Jersey Central Power & Light Company

Subject: Oyster Creek Station
Docket No. 50-219
Electromatic Relief Valve Failure

ELECTROMATIC RELIEF VALVE SOLENOID

GUIDE PIN REPAIR

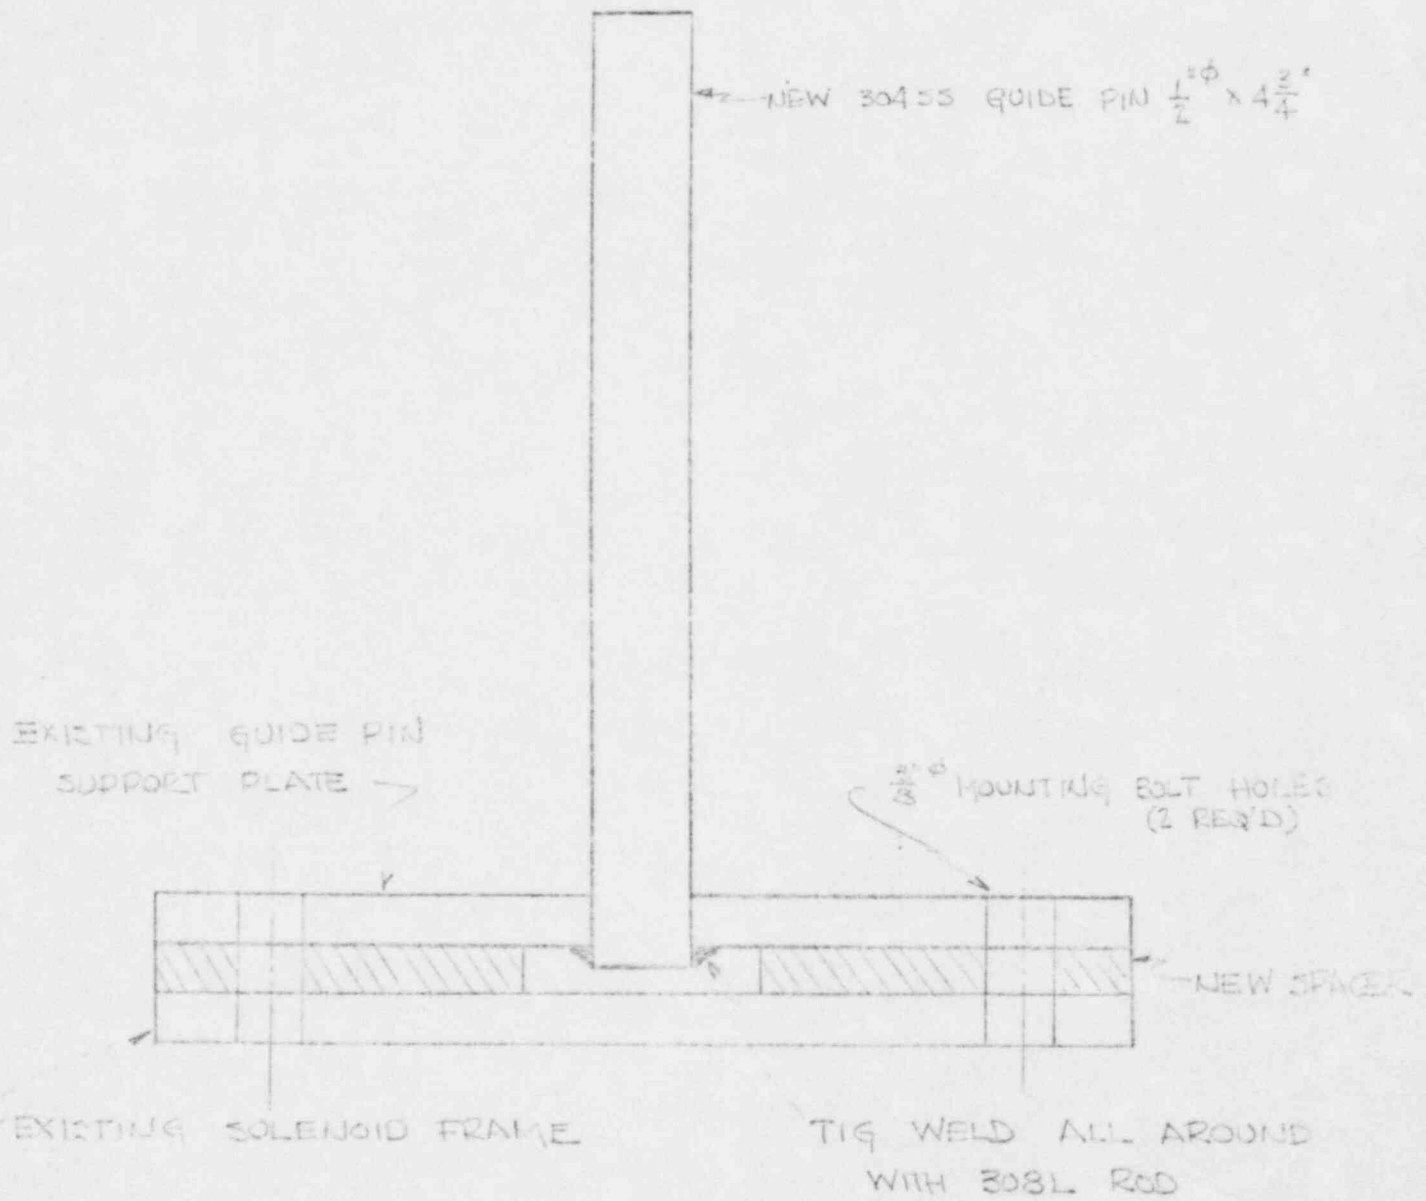
This letter is intended to follow up our April 24, 1973 letter reporting one electromatic relief valve NR-108-B failed an operability test. As a result of additional investigation into this problem, the reason for the failure of the "B" electromatic relief valve to open during the test was traced to the failure of the solenoid core guide pin as previously reported. The solenoid core is guided by two 1/2" pins silver soldered to their support plates. The soldered joint failed partially because of marginal soldering. The guide pins were cocked to one side and prevented the solenoid core from moving in the trip direction as required.

To prevent this type failure from reoccurring, the following repair was made to the pins support plate assembly of all five electromatic relief valves at Oyster Creek. (Please refer to the attached drawing.) New 304SS guide pins were machined to the dimensions shown on the attached drawing. The new pins were welded to the underside of the support plates using 308L wire. New 1/8" spacers were installed between the solenoid core frame and the guide support to clear the underside weld.
